UNITED STATES PATENT AND TRADEMARK OFFICE

APPLICATION NO.	FILING DATE	FIRST NAMED INVENTOR	ATTORNEY DOCKET NO.	CONFIRMATION NO.
10/694,599	10/27/2003	Egbert Classen	ZTP01P11003	3516

Office Action Summary

DETAILED ACTION

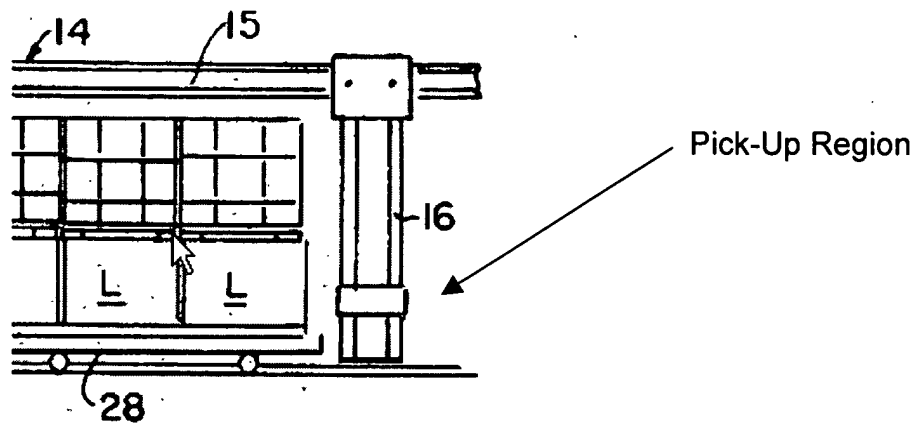
7. With respect to claim 5, referring to FIGS. 1-6 Lemelson discloses a guide and support unit 15, and a gripping unit connected to a guide and support unit 15. It is noted that the gripping unit being attached to the lifting unit

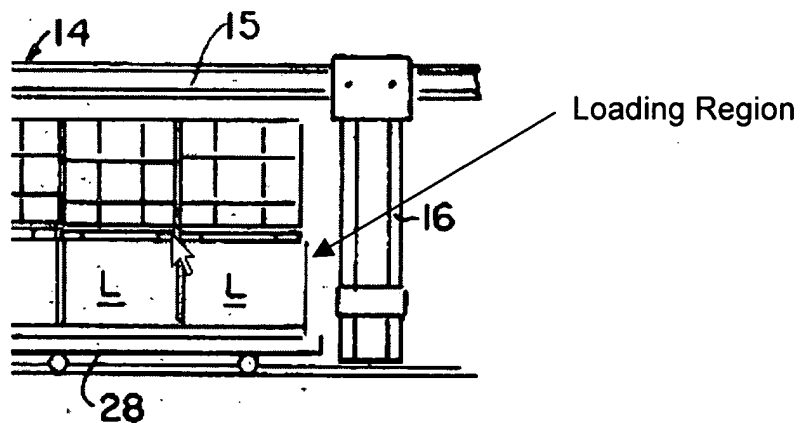
8. With respect to claim 6, referring to FIG. 5, see below, Lemelson discloses a gripping unit pick-up region, and a guide and support unit 15 above a pick-up region.

9. With respect to claim 7, referring to FIG. 5, see below, Lemelson discloses a loading region containing a ceiling mountable conveying unit 15.

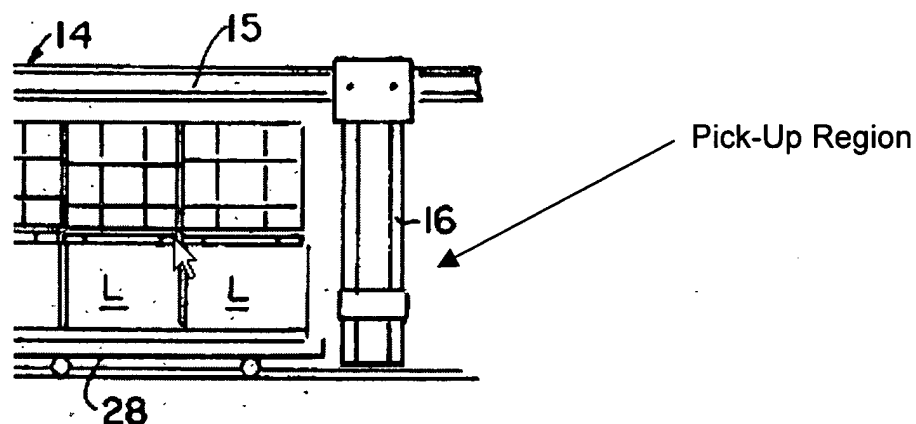
24. With respect to claim 14, Lemelson does not disclose gripping units with one degree of freedom. Referring to FIG. 3 Shimizu '219 discloses a gripping unit 9a,9b with one degree of freedom, during loading and unloading. Shimizu teaches that this allows

the goods units F to be lifted and/or released by the gripping unit 9a,9b. Col. 3, Ins. 55-65. Therefore, it would have been obvious to one of ordinary skill in the art at the time the invention was made to replace the gripper of Lemelson with the gripper taught by Shimizu, such that a gripper may lift goods units and/or release the goods units.
